City of Coral Gables Planning Department Staff Report

Subject: **Application No. 02-07-456-P. Change of Land Use, Rezoning and Site Plan Review.** St. Thomas Church/School proposes construction of a new athletic field on property immediately east of existing campus and modifications to the existing parking lots, more specifically as follows:

“St. Thomas Church and School” - Change of Land Use, Rezoning and Site Plan Review

PROPOSED SITE PLAN

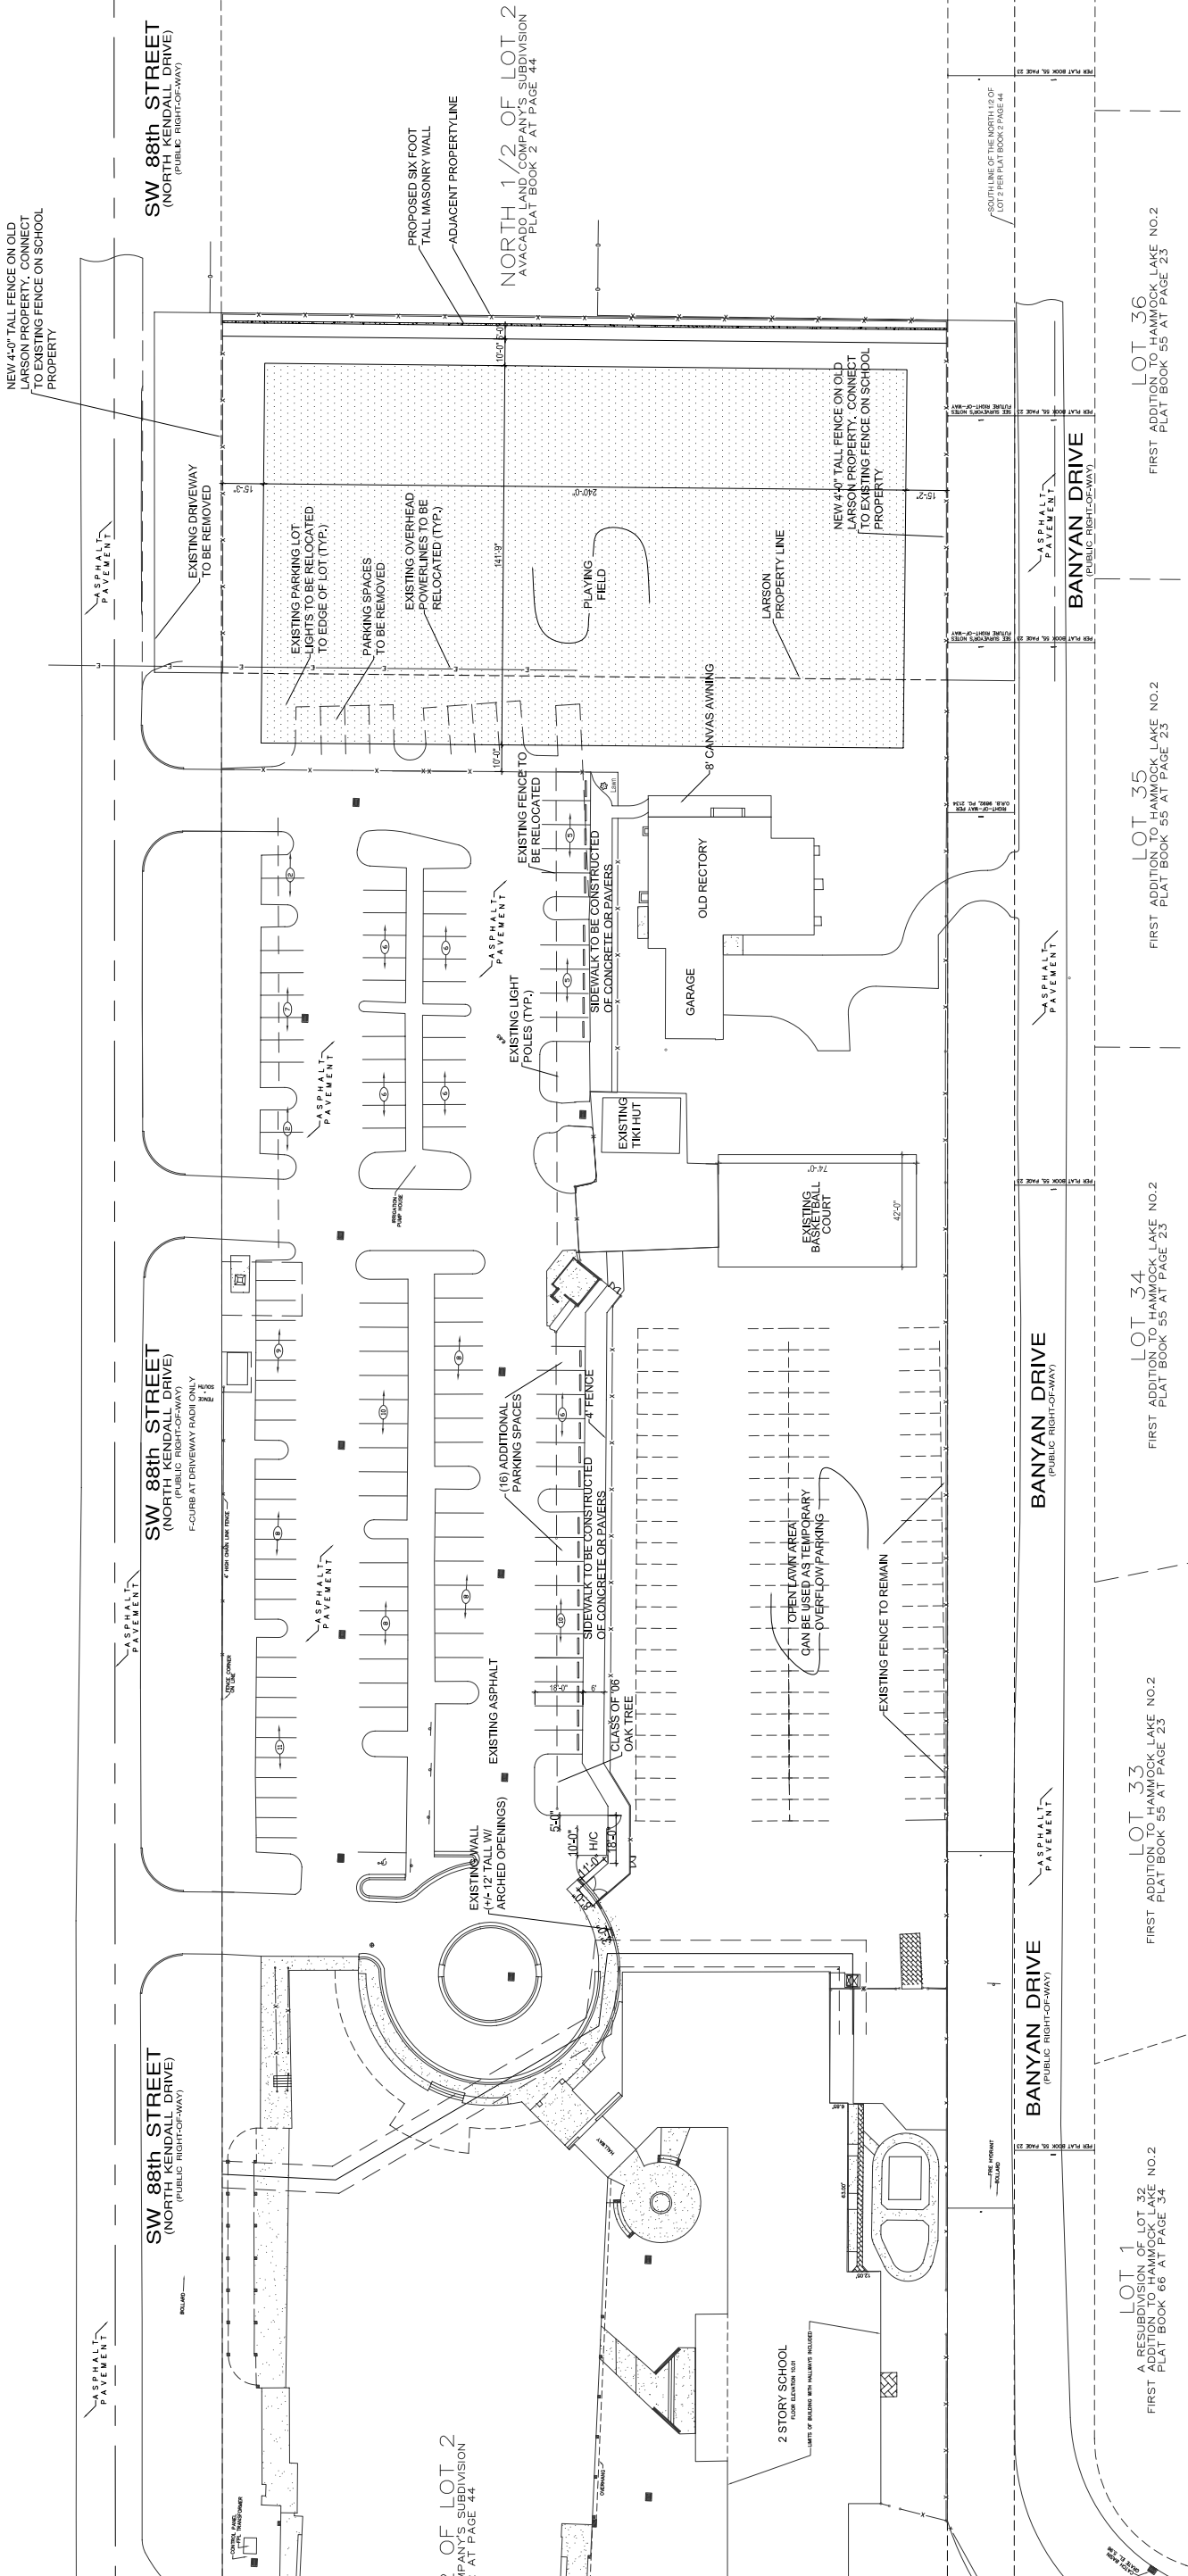
1. Application/supporting documentation. Construction of the project shall be in conformance with the following as amended pursuant to changes noted herein:

- a. Site plan prepared by Witkin Hults Design Group, dated 03.03.08.
 - b. Landscape plan prepared by Witkins Hults Design Group, dated 03.19.08.
 - c. Traffic circulation study prepared by David Plummer & Associates, dated 01.25.07.

PROPOSED LANDSCAPE AND BUFFER PLAN

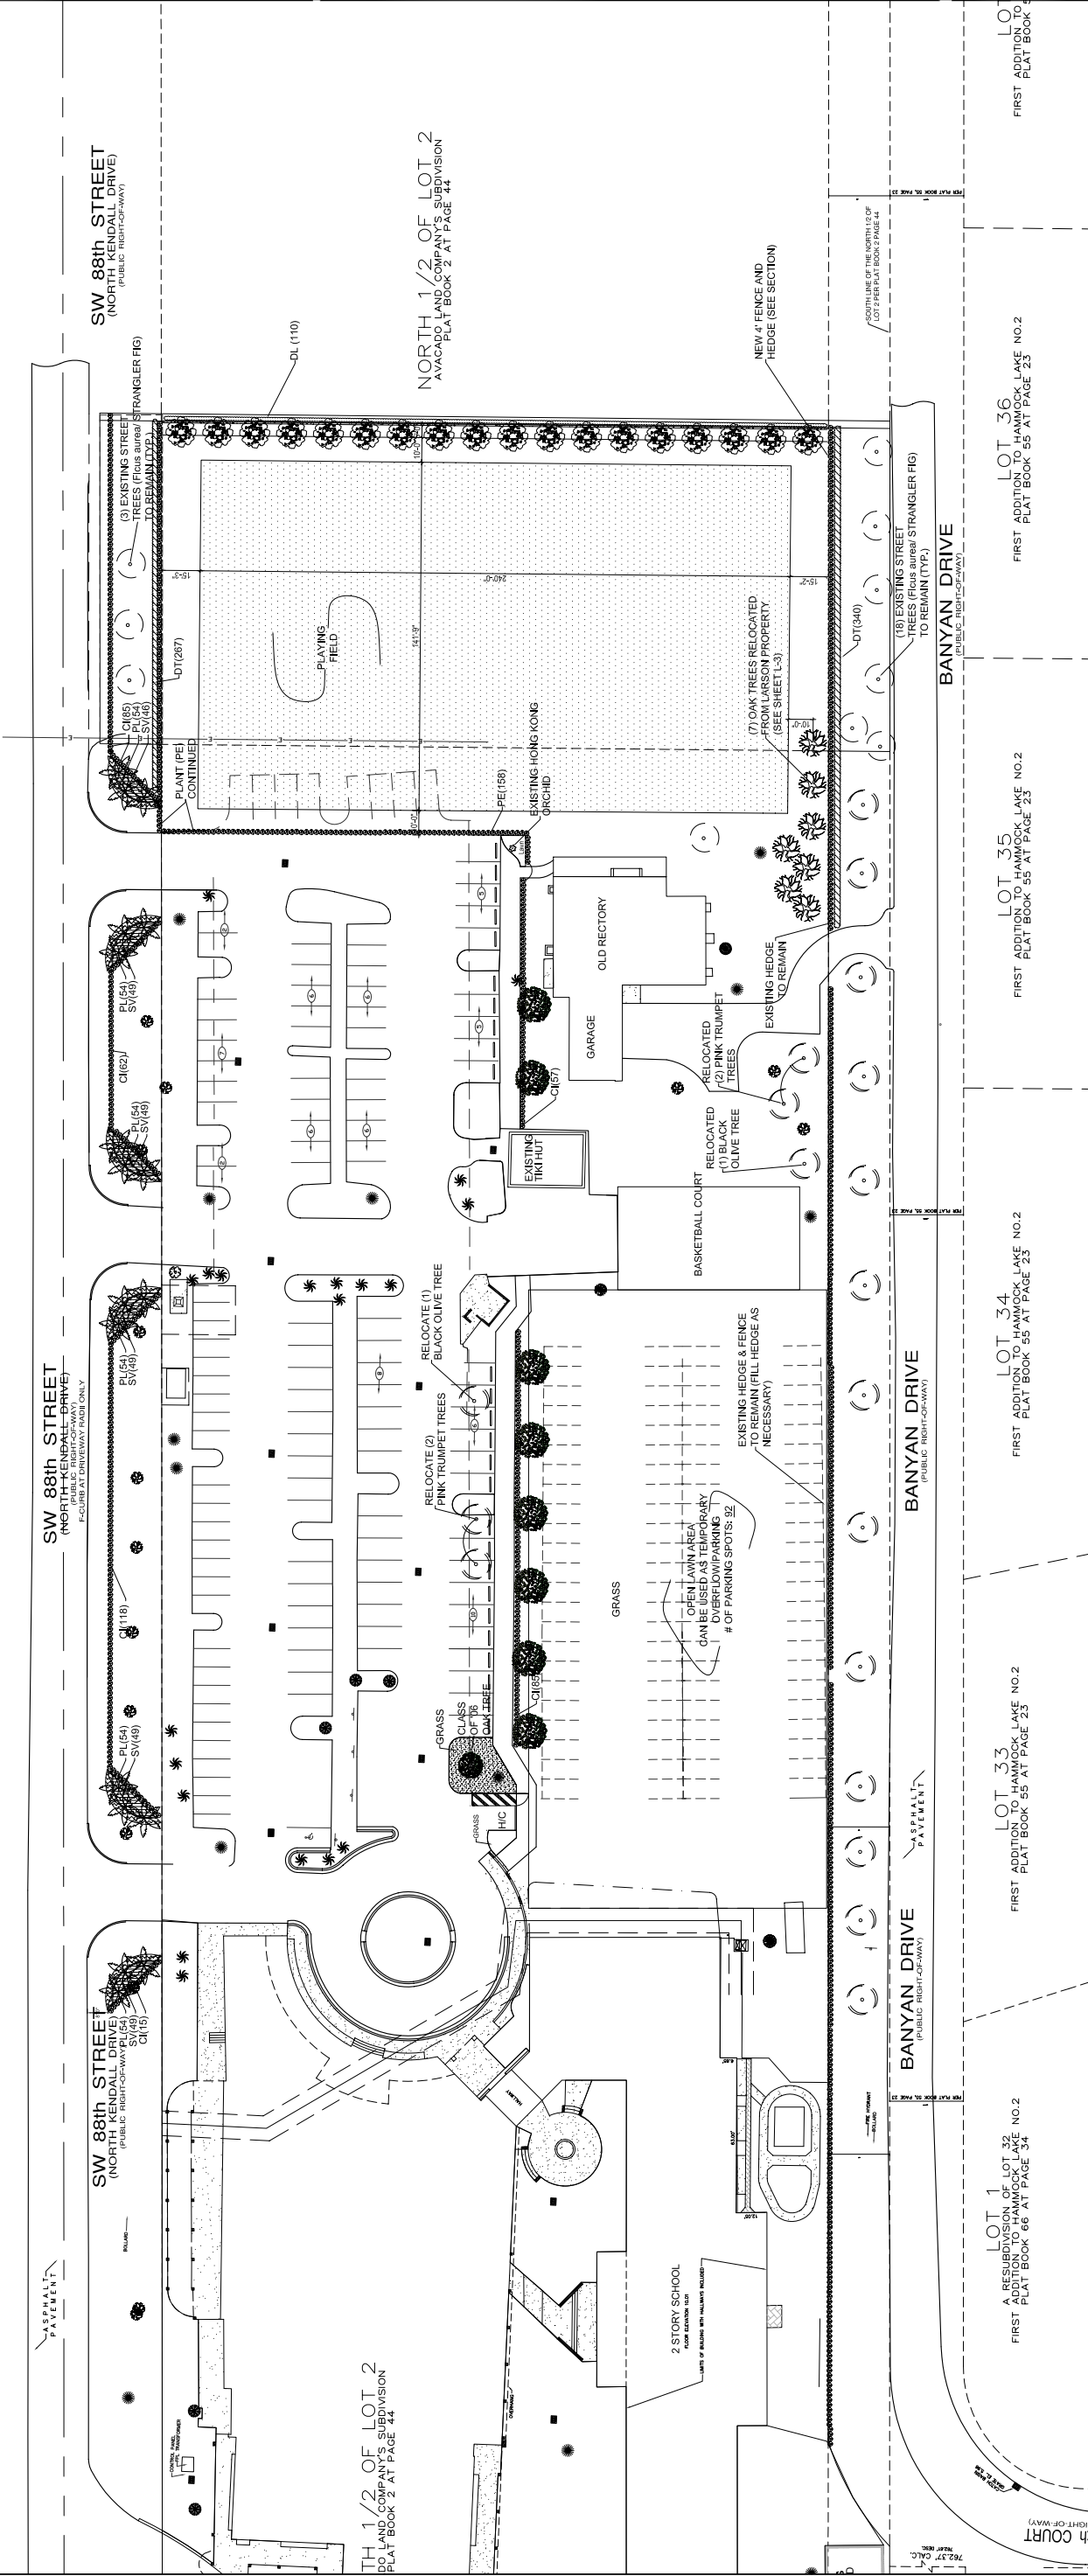
- a. Landscape buffer plan for the ten (10) foot easement on the entire eastern property line of the athletic field from North Kendall Drive to Banyan Drive to include as a minimum the following improvements:

1. Continuous six (6) foot high masonry wall on the property line; and,
 2. Continuous three (3) foot hedge/understory plant materials in front of the wall facing the athletic field; and,

3. Continuous row of twelve (12) to fourteen (14) feet Green Buttonwood overstory shade trees at a average of fifteen (15) feet on center facing the athletic field; and;

4. Irrigation.

The landscape and site plan submitted with the application proposes a four and six foot high masonry wall along the east perimeter of the athletic field, and chain link fence along the north and south perimeter of the field. Low hedge materials are proposed to be planted along the inside of the perimeter wall/fences. A single row of Green Buttonwood trees would also be planted along the inside of the east perimeter wall. Staff has recommended a minimum ten (10) foot wide landscape buffer within a perpetual landscape easement which includes a continuous six (6) foot high masonry wall, hedge and understory plant materials as well as a continuous row of canopy trees. The installation of other landscape materials is proposed along both the north and south perimeter of the new athletic field to provide further buffering. In addition, numerous other operational and use restrictions has been placed upon the athletic fields to provide further mitigation of any potential negative impacts of the facility.
